QUAD CITIES NUCLEAR POWER STATION UNIT 1

AMENDMENT TO FACILITY OPERATING LICENSE

Amendment No. 61
License No. DPR-29

ATTACHMENT TO LICENSE AMENDMENT NO. 61

FIGURE
3.5-1

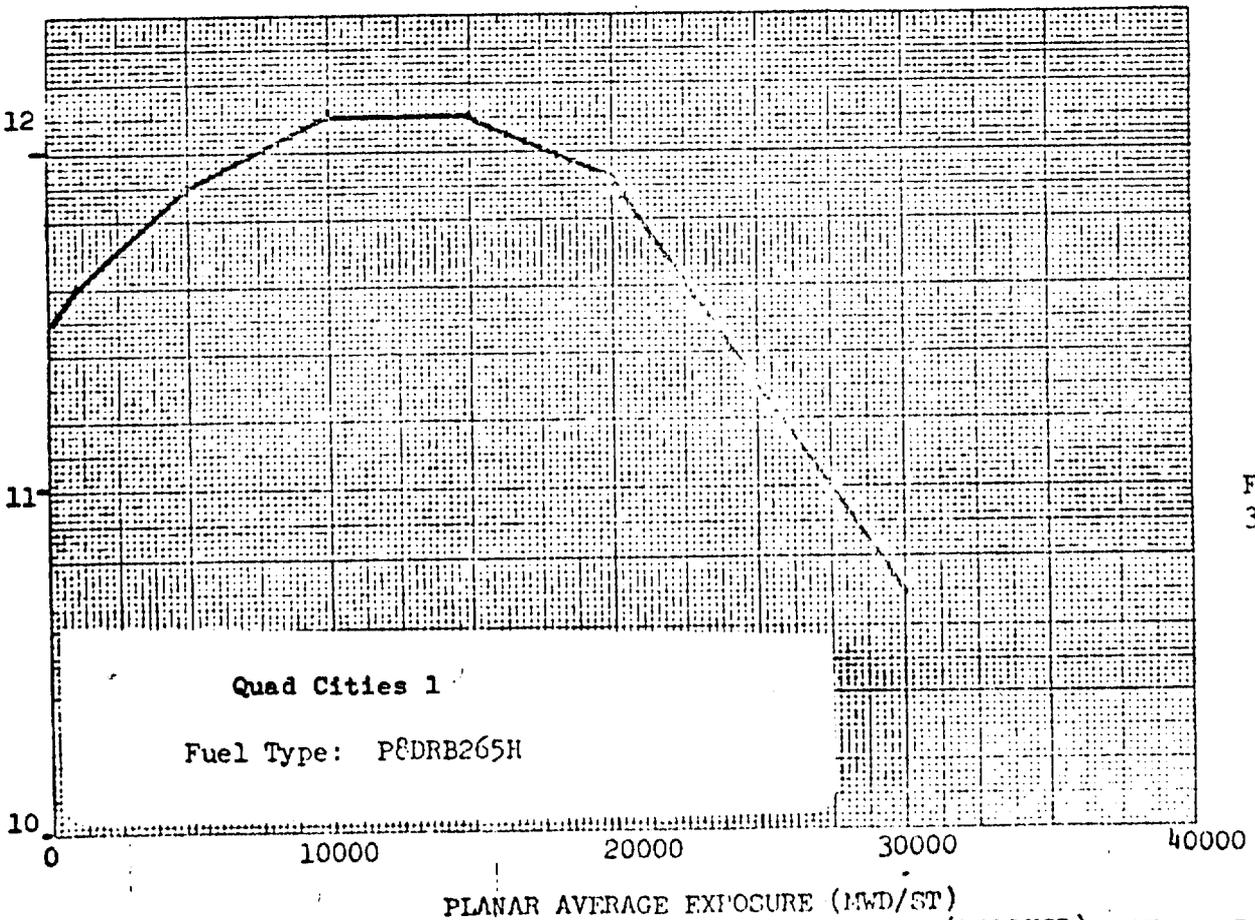
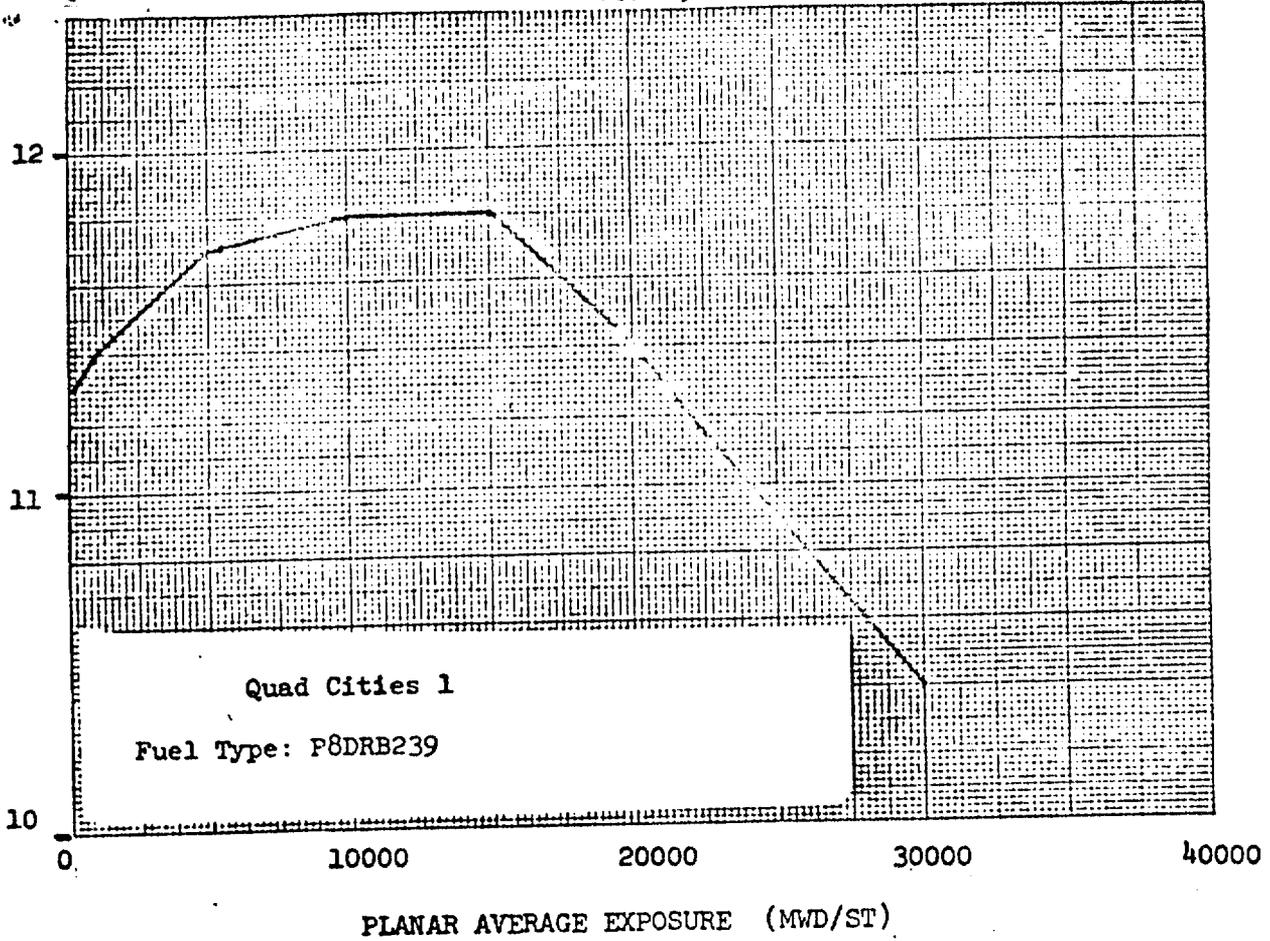
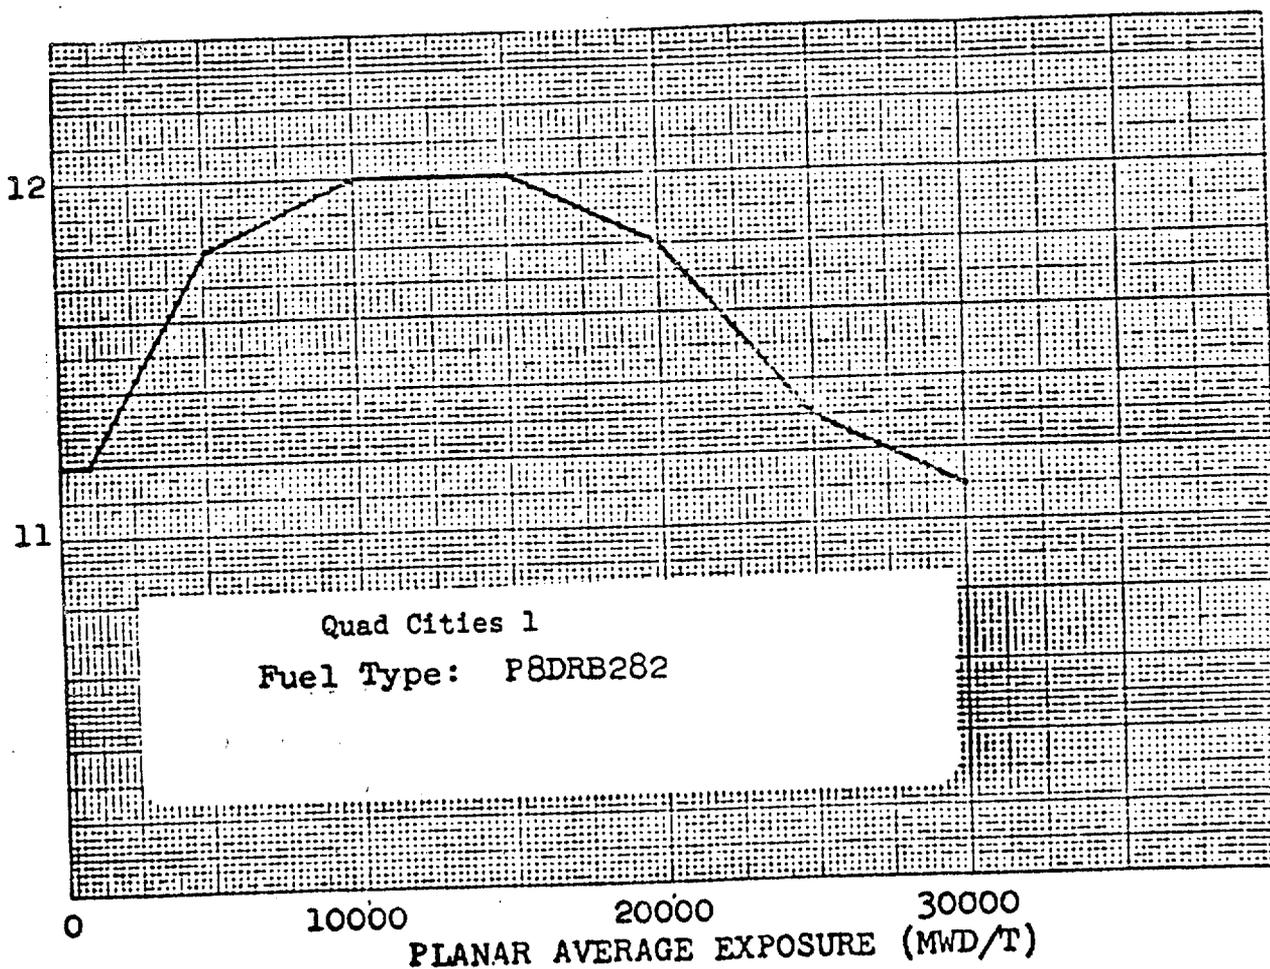
2. Page 1.1/2.1-2a is added.
3. Figure 2.1-2 is deleted.
4. Figure 3.5-1 is being replaced by 6 pages.

During steady-state power operation, the average linear heat generation rate (APLHGR) of all the rods in any fuel assembly, as a function of average planar exposure, at any axial location, shall not exceed the maximum average planar LHGR shown in Figure 3.5-1.

The peak cladding temperature following a postulated loss-of-coolant accident is primarily a function of the average heat-generation rate of all the rods of a fuel assembly at any axial location and is only secondarily dependent on the rod-to-rod power distribution within an assembly. Since expected local variations in power distribution within a fuel assembly affect the calculated peak cladding temperature by less than $\pm 20^\circ\text{F}$ relative to the peak temperature for a typical fuel design, the limit on the average planar LHGR is sufficient to assure that calculated temperatures are below the limit. The maximum average planar LHGR's shown in Figure 3.5-1 are based on calculations employing the models described in Reference 2.

Maximum Average Planar Linear Heat Generation Rate (MAPLHGR)
